**2006 IRC
Recommended Action for IRC Section R602.10.5
Continuous Structural Panel Sheathing (Wall Bracing)**

Missouri Jurisdictions Adopting the 2006 IRC

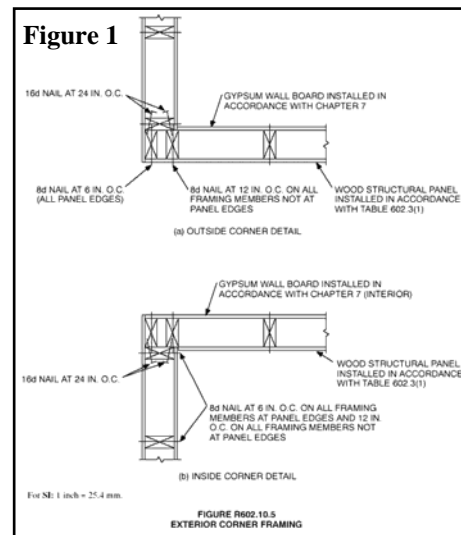
A more appropriate solution to the above concern would have been to clarify that the corner detail in Figure R602.10.5 (see Figure 1 above) requires a minimum 2-foot corner return panel at the ends of a continuously sheathed braced wall line. This would appropriately allow a transition to other bracing methods on other wall lines while also properly adhering to the research data that supports the continuous sheathed bracing method first introduced in the 2000 IRC.
